Job Name: SAS Superstructure

Subject: NCR No. ZPMC-0165

Reference Description: Installation of Diaphragms on Various DP's

Procedural Procedural Descriptor: OBG Deck Panels

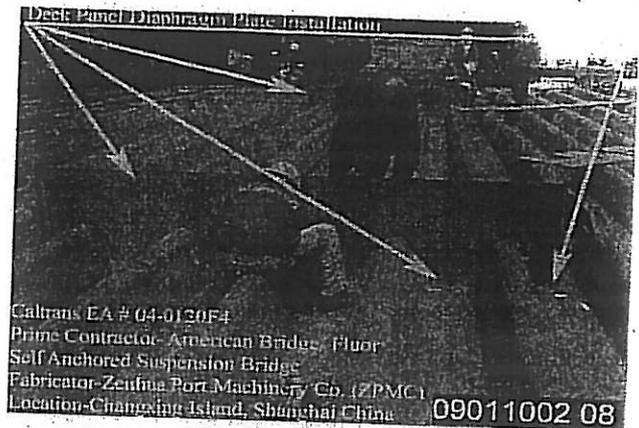
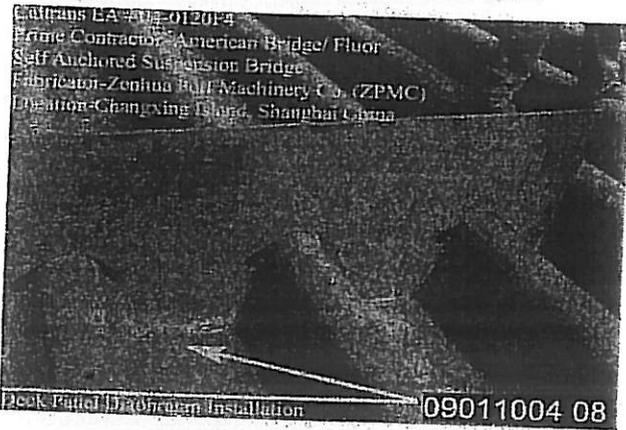
The Contractor has not complied with the written order of the Engineer to suspend work. The Contractor performed fit-up and tack welding of diaphragm plates to deck panels after the issuance of a State Letter directing the Contractor to suspend such work.

Procedural Procedural Descripton: OBG Deck Panels

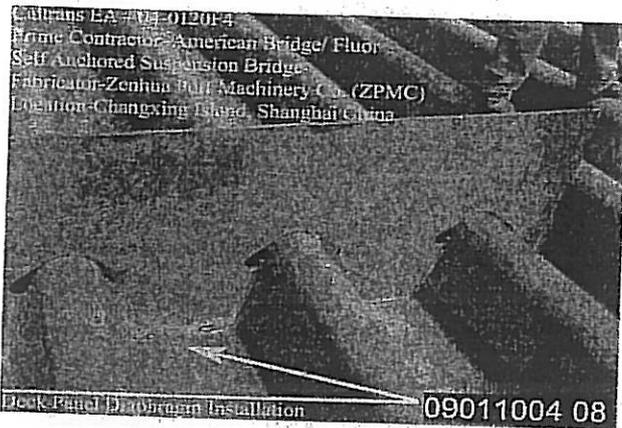
The proposed resolution is acceptable. The inspection documents requested in Rev 3 of NPR-0152 have been provided. Also, each of the panels in question has subsequently been green tagged. The Department concurs that Non-Conformance ZPMC-0165 is closed.

Submit phased array ultrasonic testing data verifying that the deck panels in question are in conformance with the Contract requirements.
